Product Change Notification

PCN-016_2022_1-OMTM2202801

Second source primary enamel wire/conductor

HY series – **First date code**

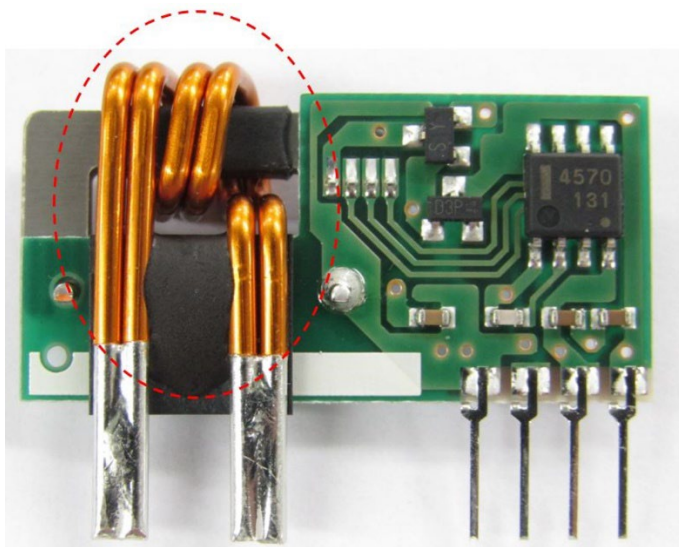
Add alternative 2nd source for primary Enamel wire/conductor.

The insulating material of enamel wire used for the current primary coil/conductor is PVF (Polyvinyl fluoride).

Alternative enamel wire insulation material is PEW (polyester).
